# Priestthorpe Accessibility Action Plan March 2023

## 4.1 - ACTION TABLE

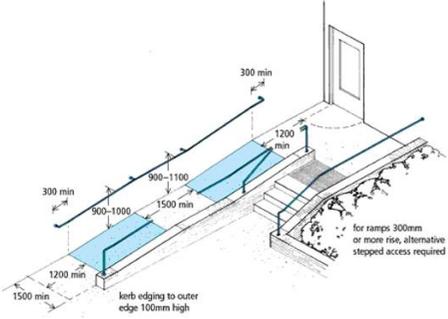
9.2	The small ramp featured a steep gradient and was not colour contrasted to indicate the change in level.	The ramp should be subject to remedial works to reduce the gradient to a reasonable slope that can comply with ADM-2:1.26 and BS8300 requirements.	M

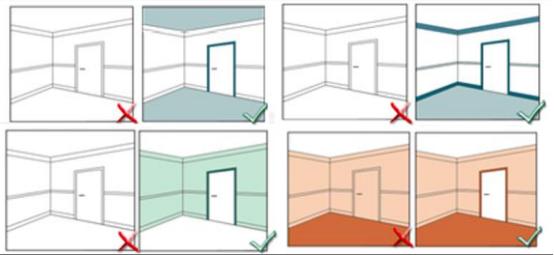
<p>5.4</p>	<p>Steps were required at the main entrance. The auditor was informed of potential future developments for this entrance to be ramped to avoid the extended route around the school. The height of the steps was approximately 1500mm.</p> <p>Signage was provided to direct people to an alternative entrance. The phrase “disabled access” requires changing.</p> <p>Steps were required into the trust area; the alternative entrance was not signposted from here.</p>	<p>The access limitations of the premises and the alternatives must be communicated via the website.</p> <p>Suitable signposting should be provided to direct disabled people to an alternative accessible entrance. Any signage provide should feature the access symbol and correct directional arrow. The alternative entrance must be open and available for use or have suitable procedures in place to provide assistance on demand.</p>  <p>Should a ramp be constructed at the main entrance, it must comply with BS8300 and ADM-2:1.26 requirements. Any permanent ramp must be a maximum 1:12 over a maximum going of 2m, it should be a minimum 1.2m wide and feature 1.2m landings at head and foot, handrails to both sides and a contrasted sloped surface.</p>	<p>M/ST</p>

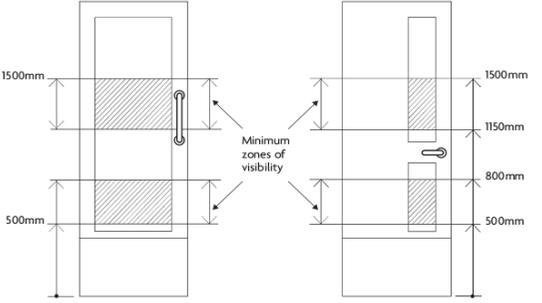
5.8	<p>The entry phone system was approximately 1450mm from ground floor level, which may not be accessible for people who are short in stature.</p> <p>The intercom at the accessible entrance was audio only. A camera was provided for reception to see this area; however, people who are Deaf or have hearing loss may find accessing this control difficult.</p> <p>The intercom at the main entrance was high from ground floor level and may not be accessible for all users.</p>	<p>Consider installing intercoms which have tactile definition to the buttons and an LED display. Ensure all operating parts are within 1050mm off the landing level and ensure no obstruction below. Ensure that it is well contrasted against the background upon which it is seen.</p> <p>☒ Note AD M is not descriptive on intercoms and BS8300, best practice should be referred to. In all cases when installing intercoms specialist advice should be sought.</p> <p>☒ BS8300 States - Entryphone systems should be sited for approach and use from a wheelchair and should contain a light emitting diode (LED) display to enable people who are deaf and hard of hearing to use them. the means of indicating that the call is acknowledged and that the lock has been released (if permitted) should be both audible and visible. the Entryphone system should contrast visually with the background.</p> <p>Where the entrance point does not provide a clear view of the reception area, make sure that a phone number or suitable alert and management system are in place to provide alternative access for anyone that cannot operate the intercom.</p>	M/N	CCTV in place, intercom is accessible.
